Issue Date: August 21, 2020

TO BIDDERS ON: HIGHLAND HOSPITAL KORET Building Exhaust Fan and Waterproofing
1131 East 31st Street
Oakland, California

END OF ADDENDUM NO. 02

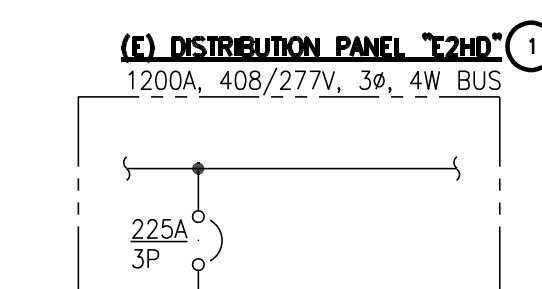
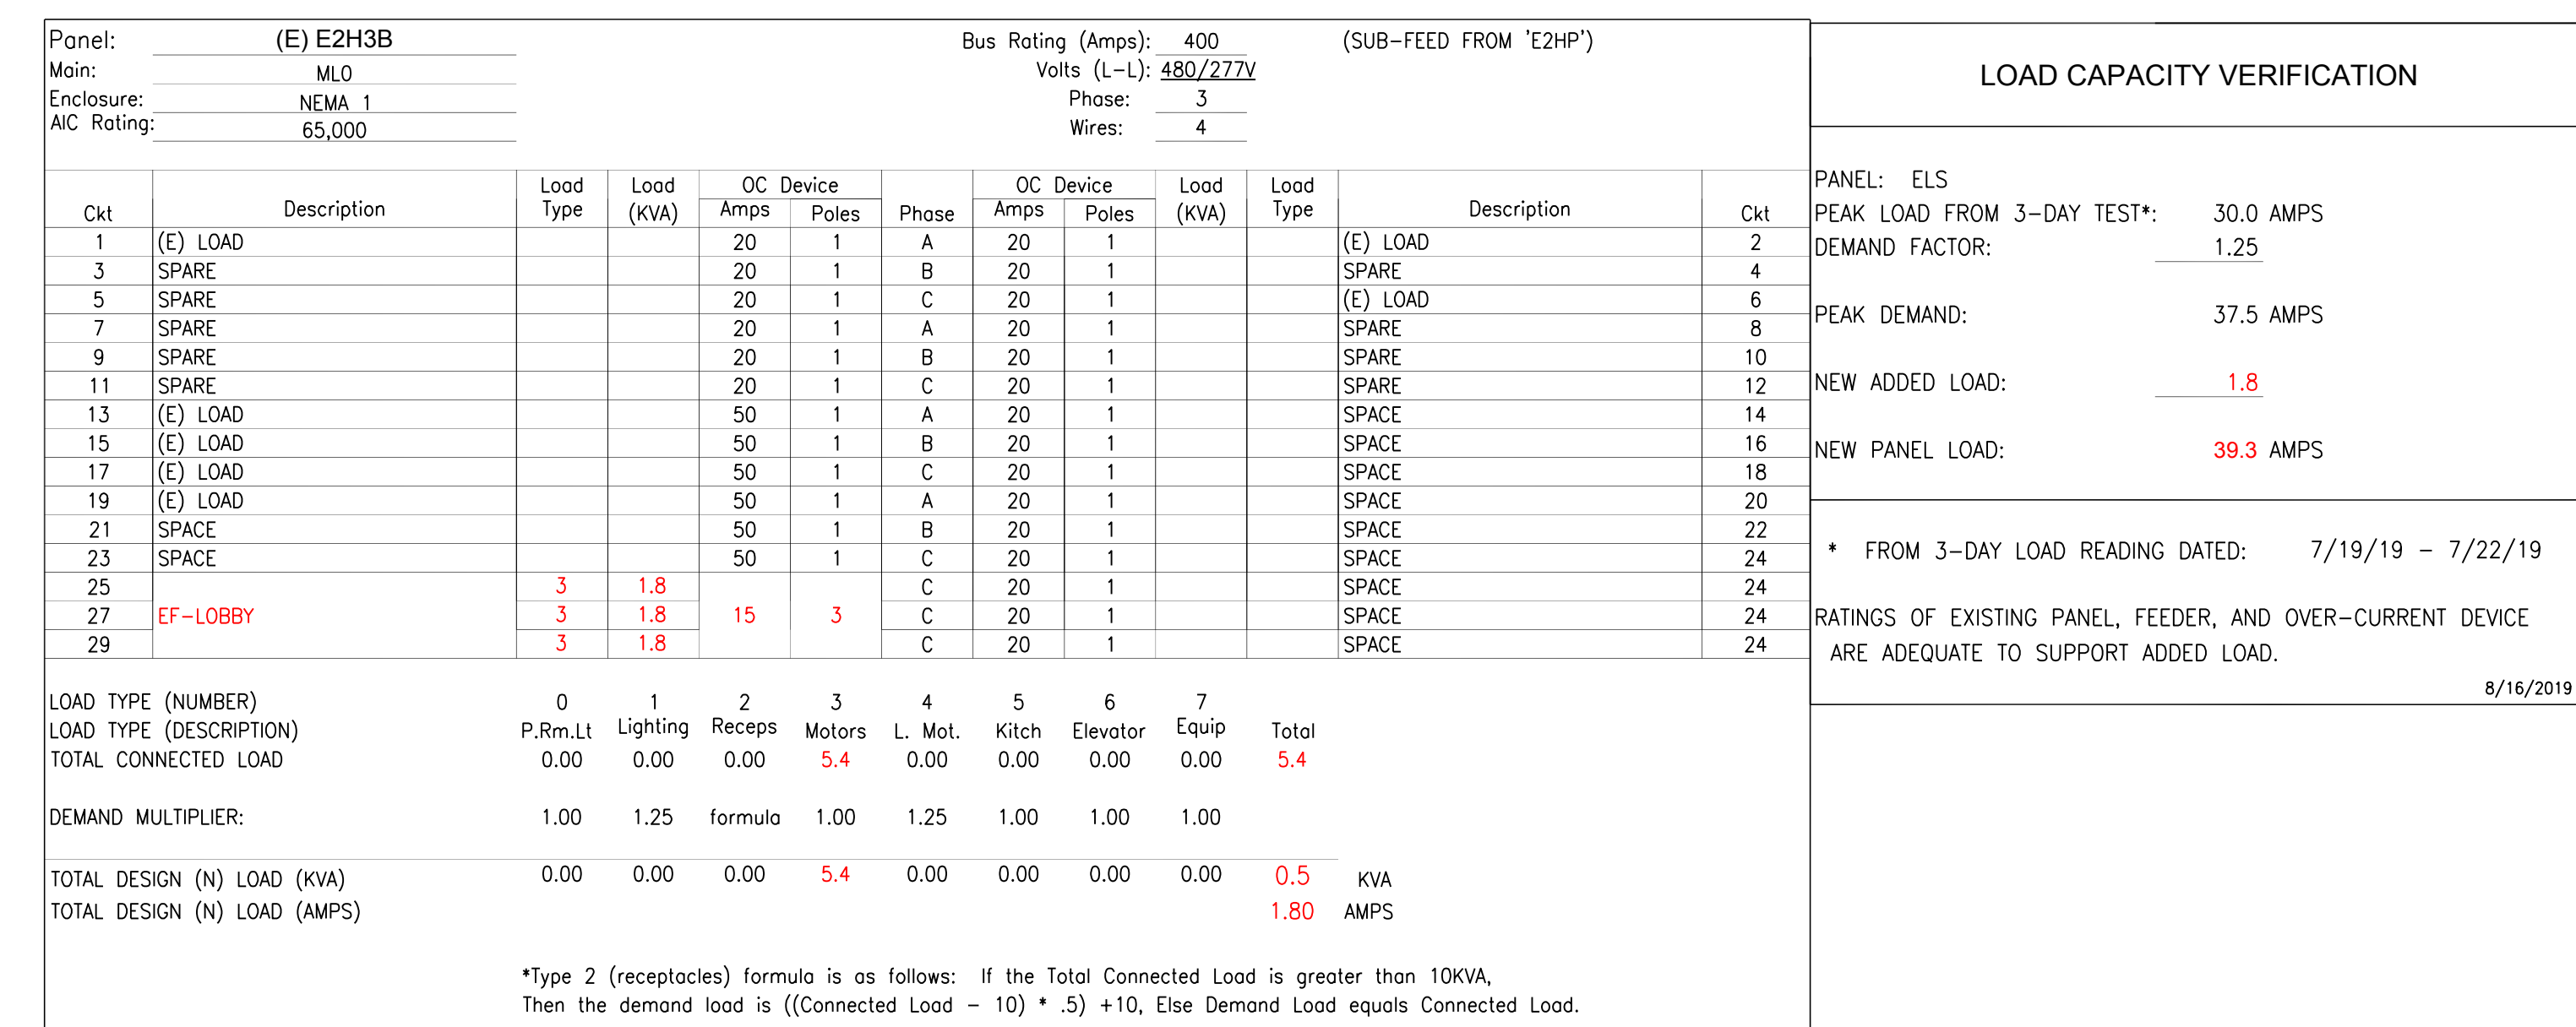
6. What BMS Controls to be used for the Lobby Exhaust Fan?

Response: Drawing M1.0 identifies controls work indicating that the BMS controls the start/stop function and receives the failure alarm. The BMS is a Siemens system. The Contractor should be contacting Siemens for pricing of that work.
